**ADDENDUM
NO. 2**

**CROWN POINT COMMUNITY SCHOOL CORPORATION -
ATHLETIC TURF IMPROVEMENTS
Crown Point, IN 46307**

ADDENDUM TWO

Addendum Two (AD.02) to the drawings and specifications prepared by Gibraltar Design and The Skillman Corporation for **Crown Point Community School Corporation – Athletic Turf Improvements** for Crown Point Community School Corporation, Crown Point, Indiana.

C-1.3

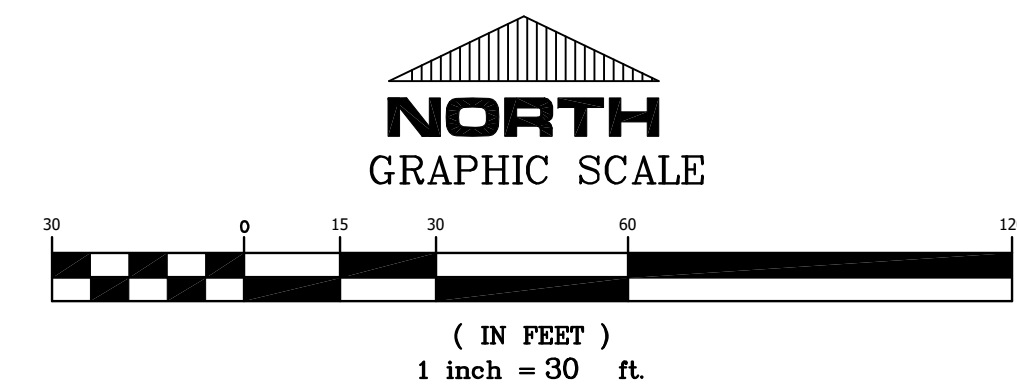
3. Sheet C-1.3

- A. Refer to attached revised full-size drawing, included in this Addendum, for revisions.

C-2.3A

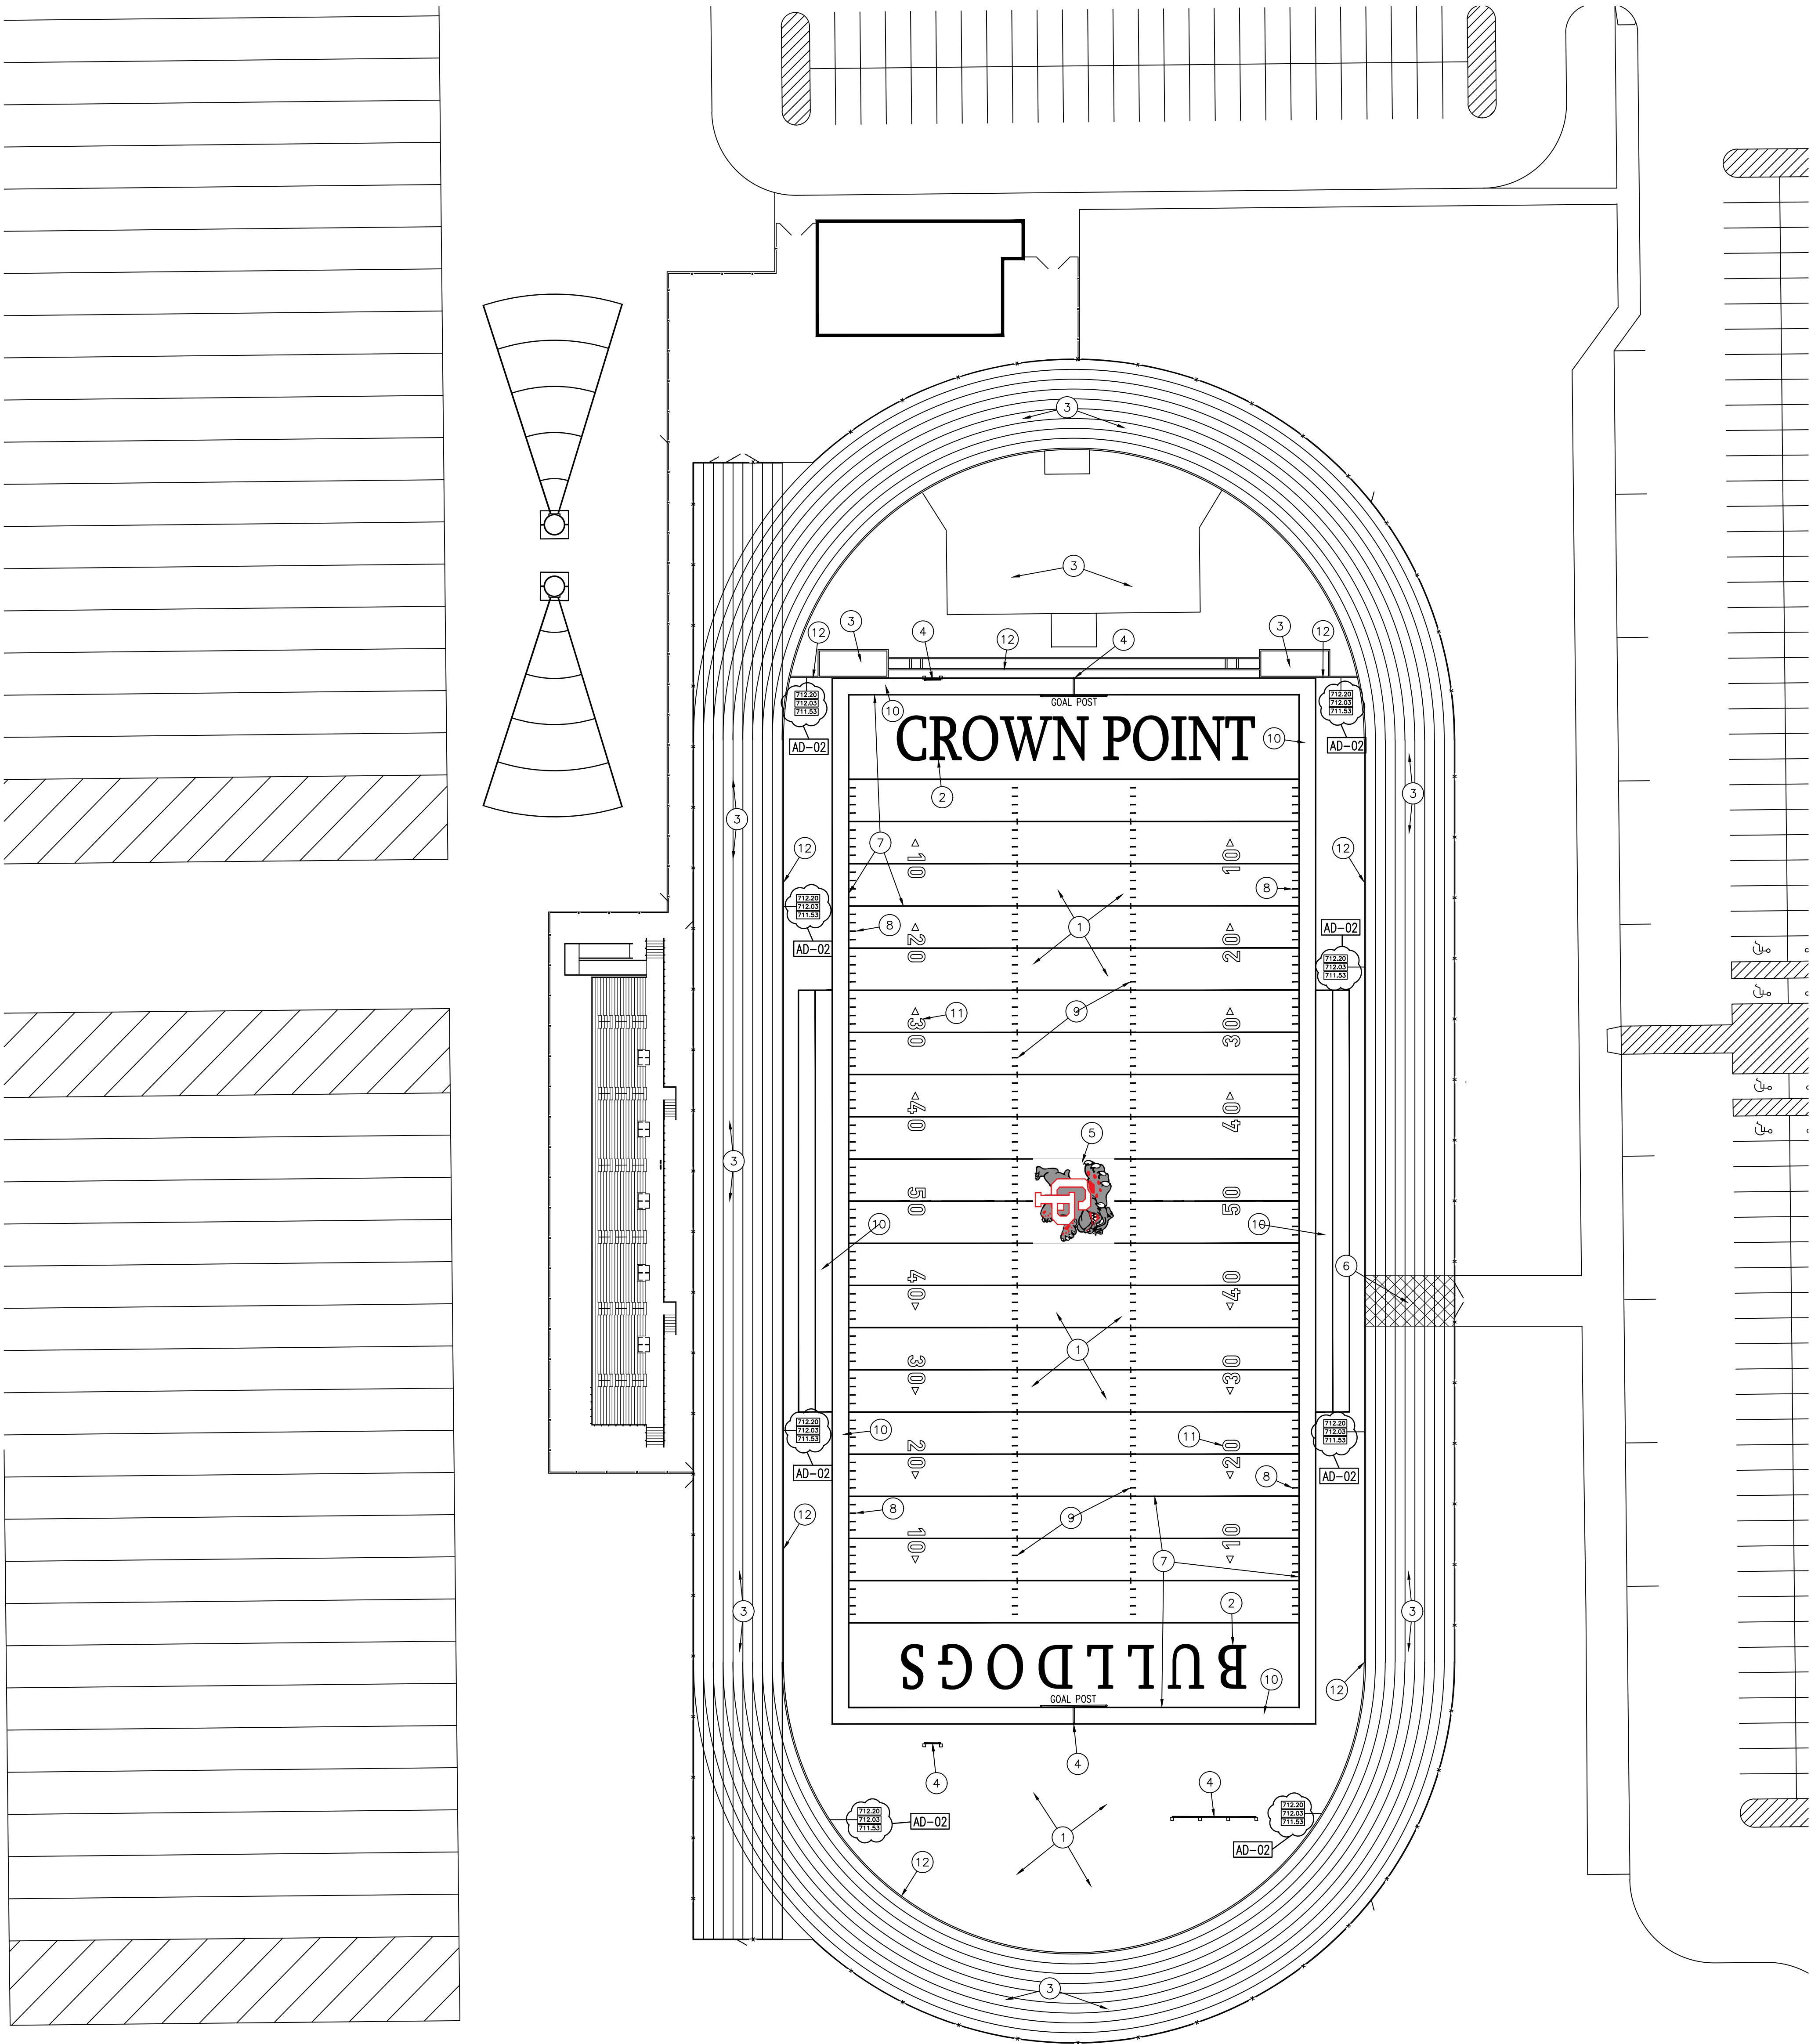
**5. Sheet C-2.3A**

- A. Refer to revised, full-size drawing, included in this Addendum, for revisions of curb, stone, and subgrade elevations.

C-4.1

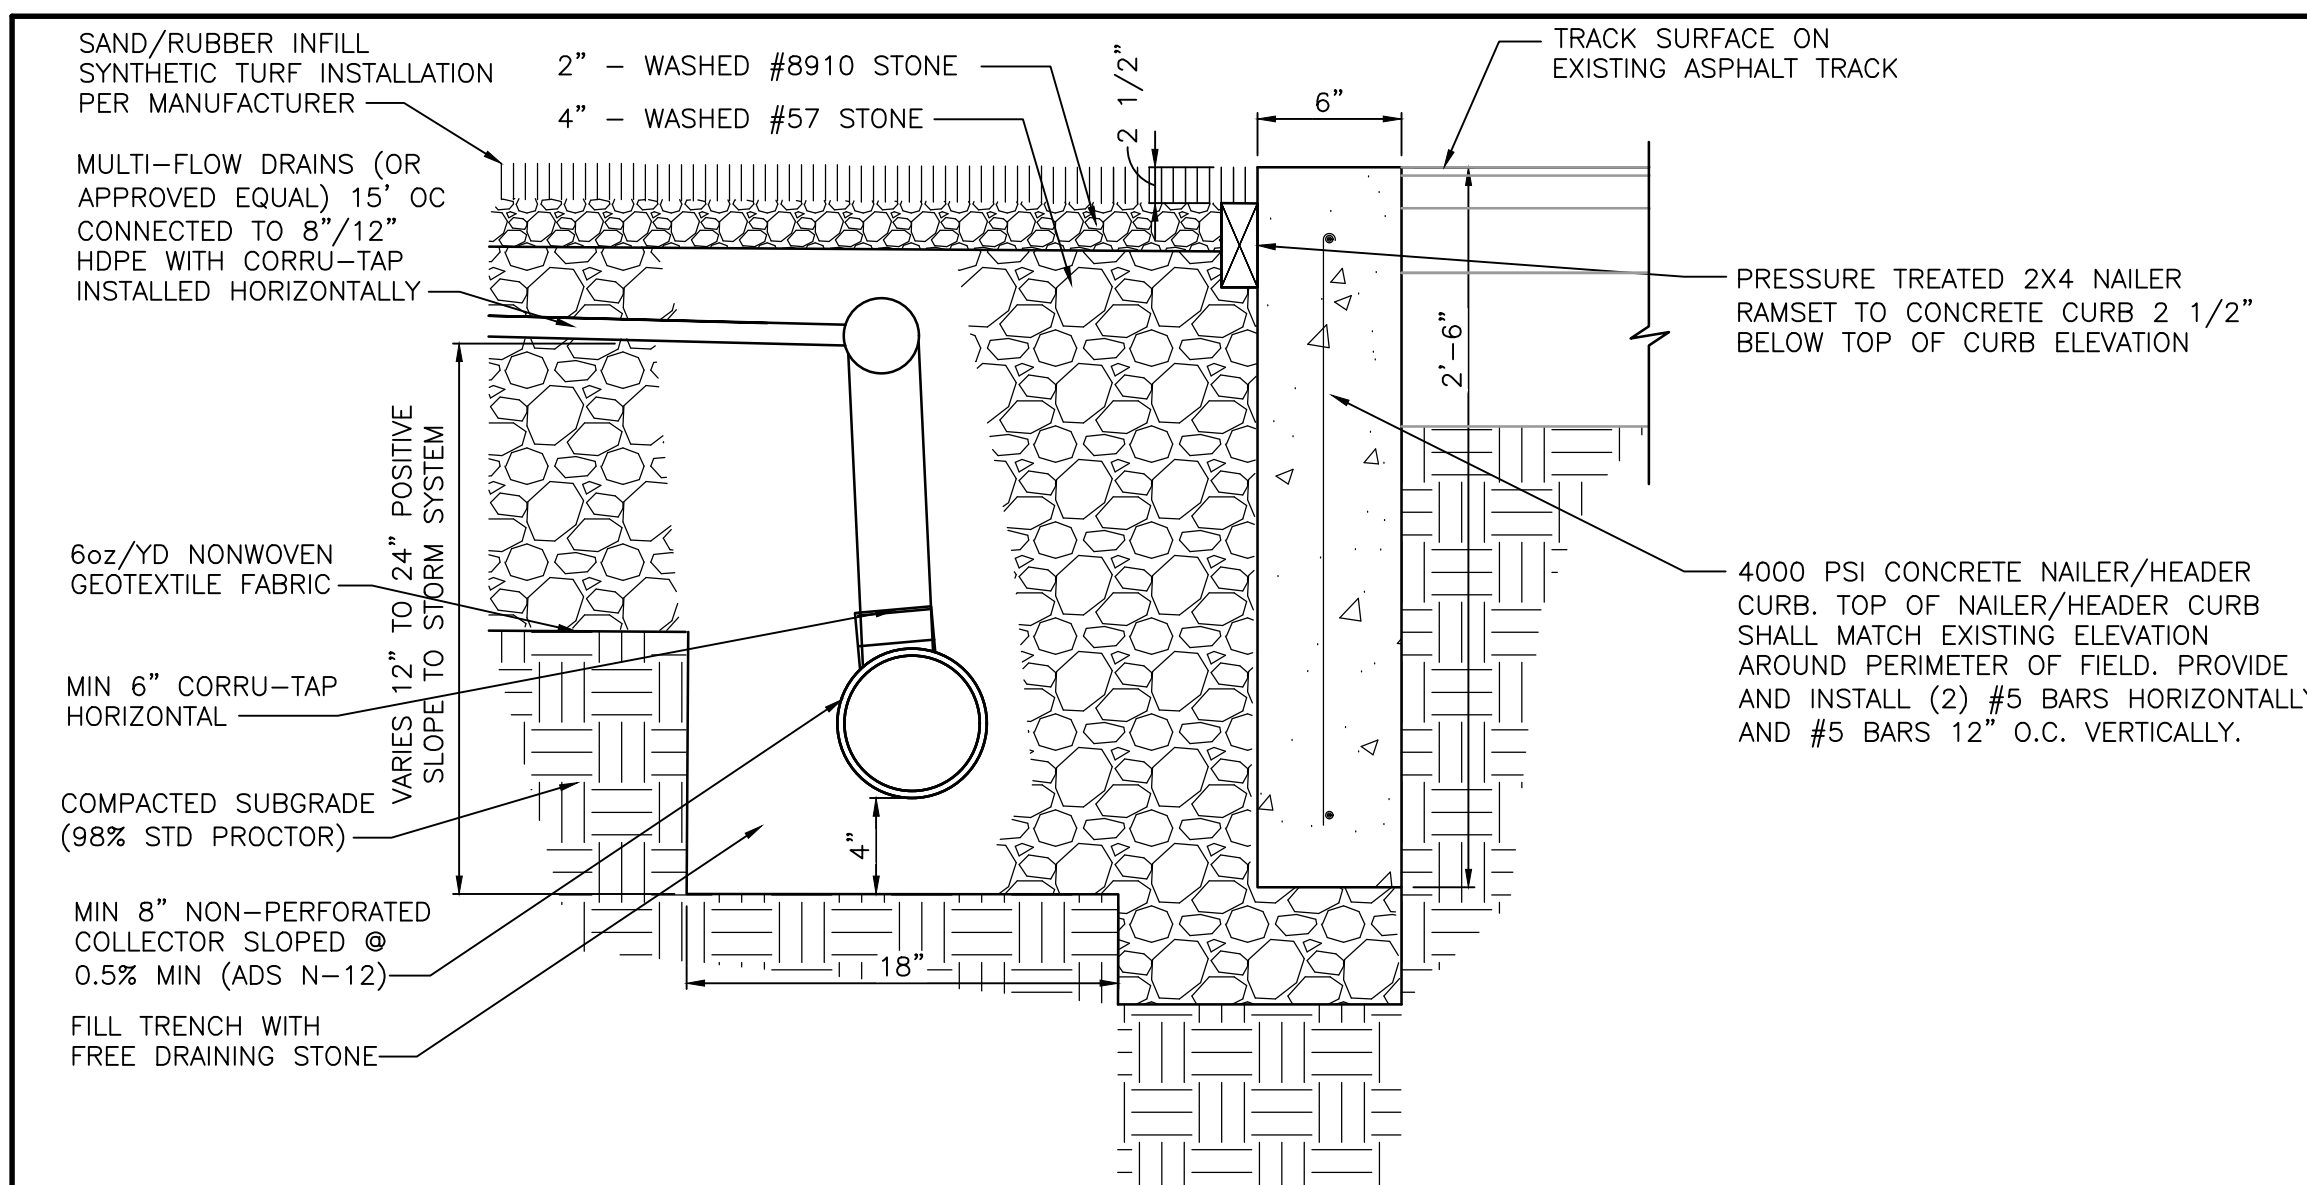
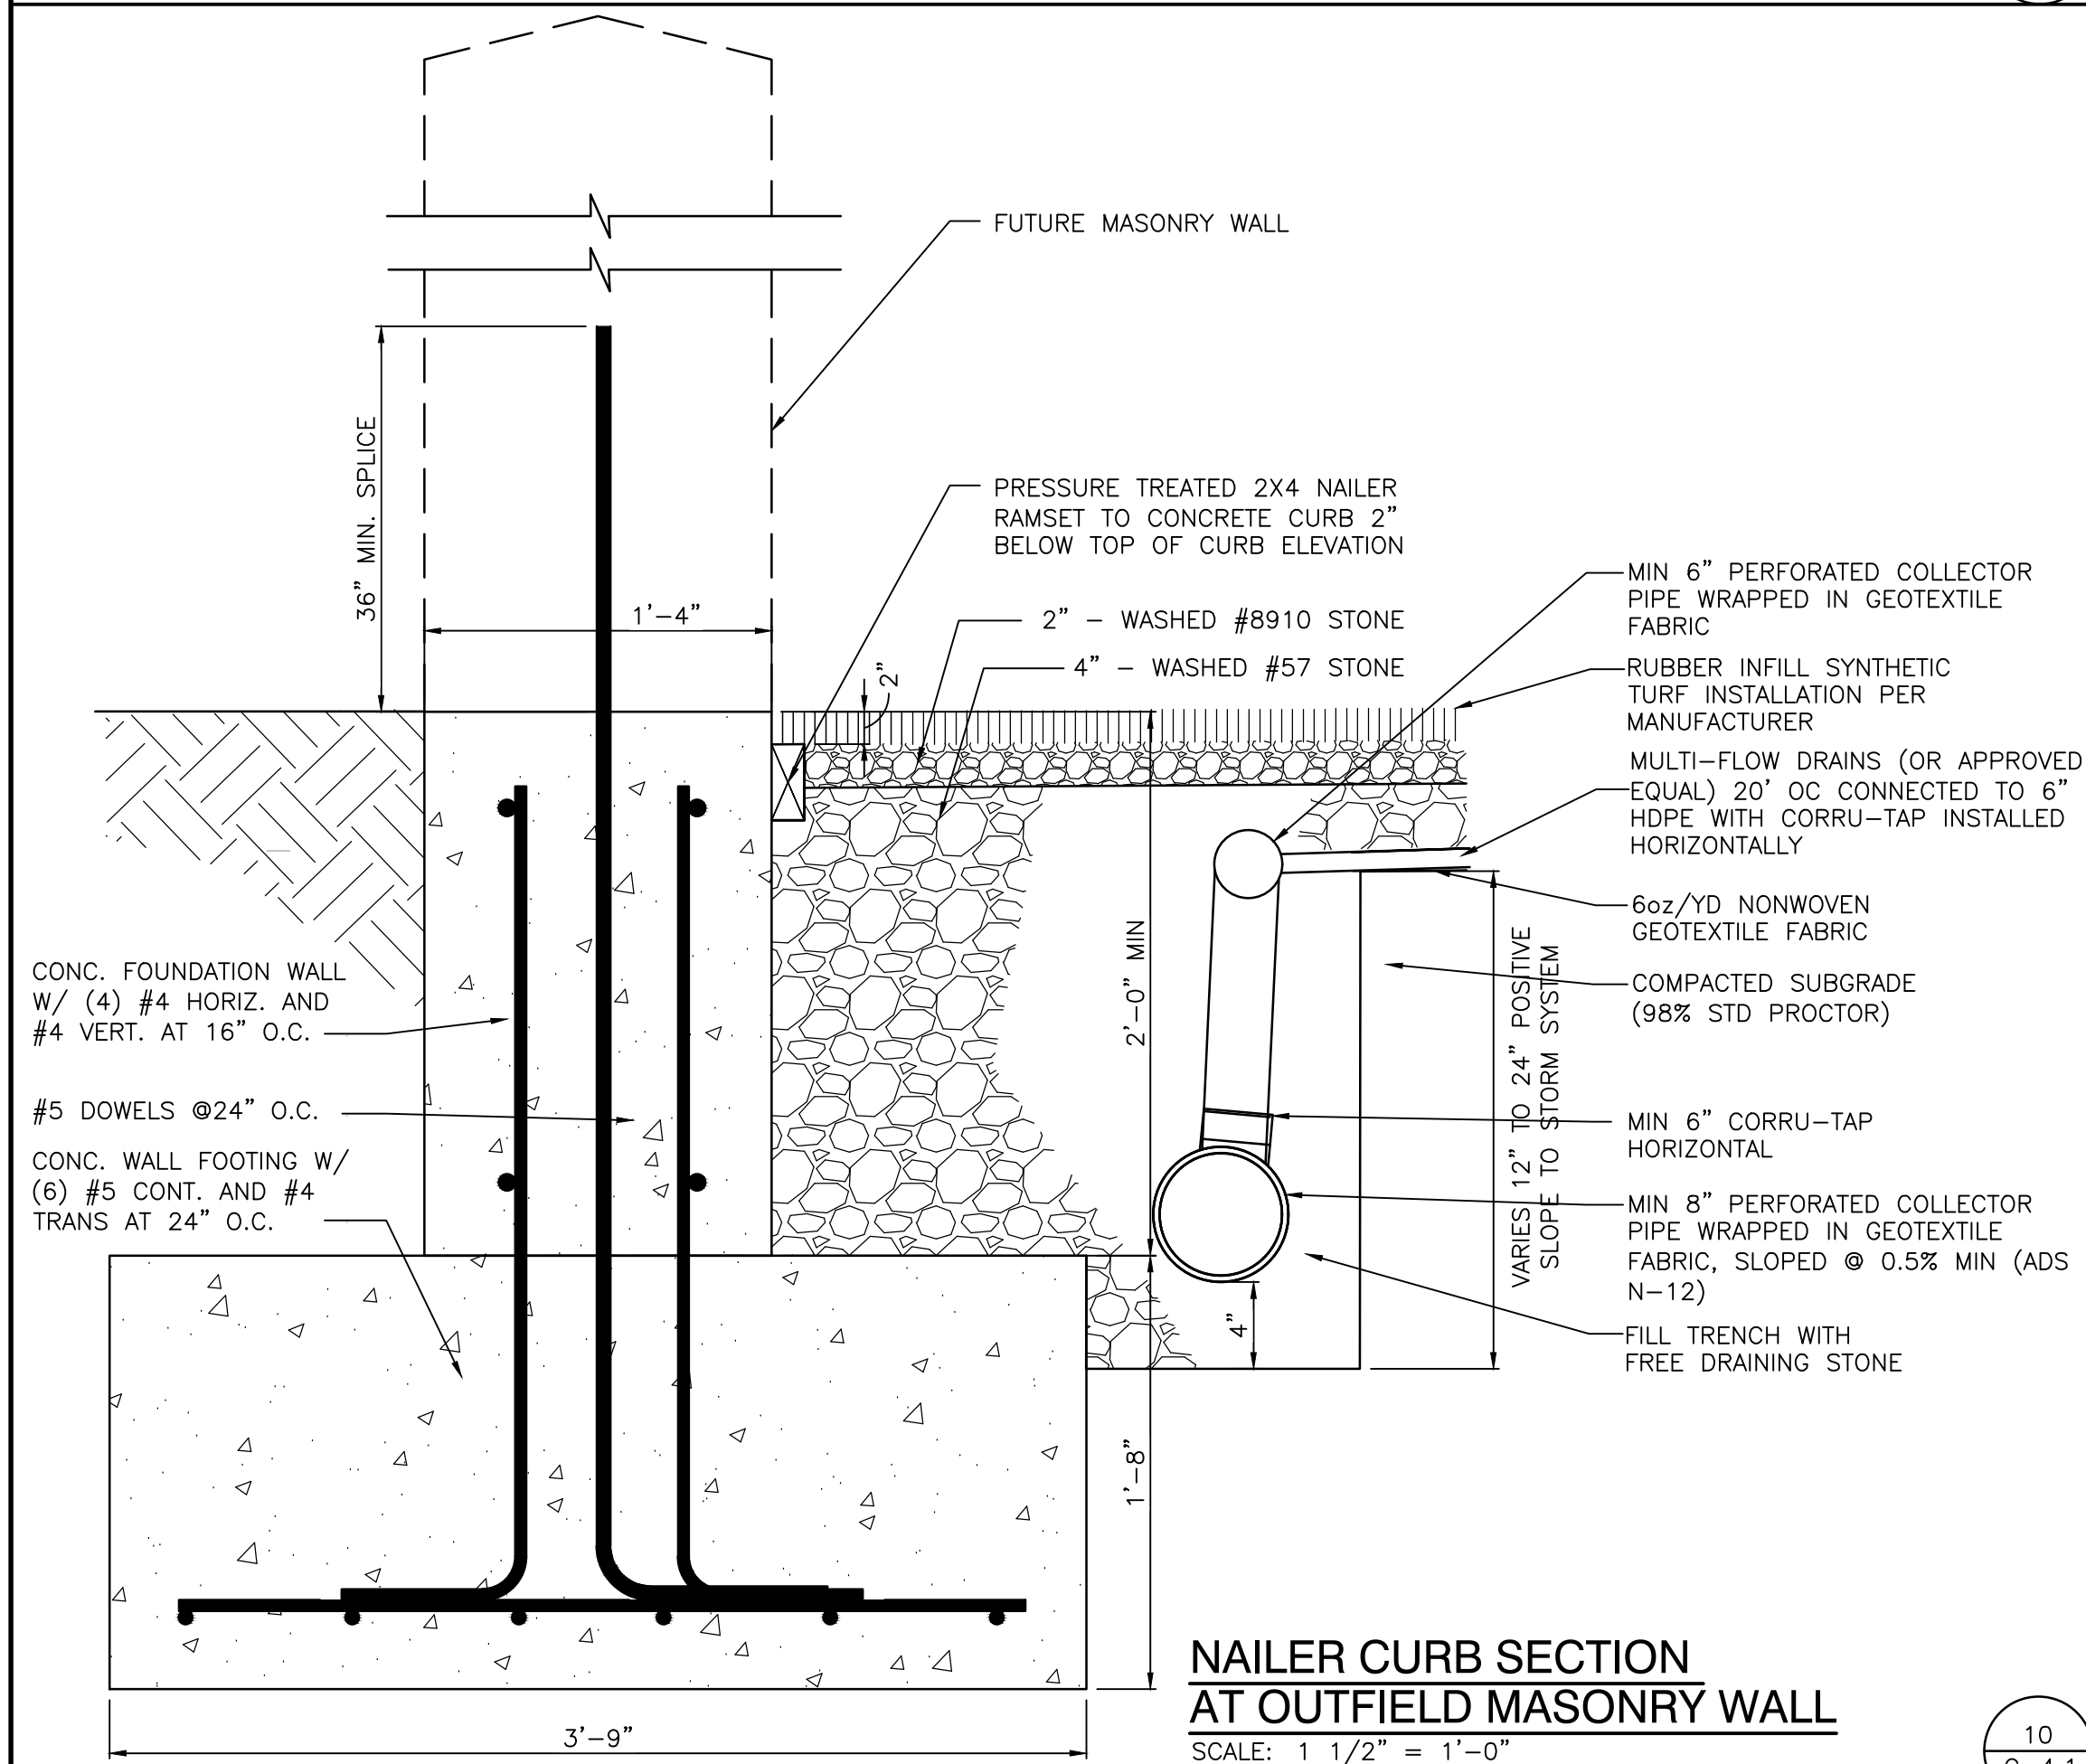
7. Sheet C-4.1

- A. Refer to revised, full-size drawing, included in this Addendum, for revisions to detail 5/C-4.1 and 8/C-4.1.
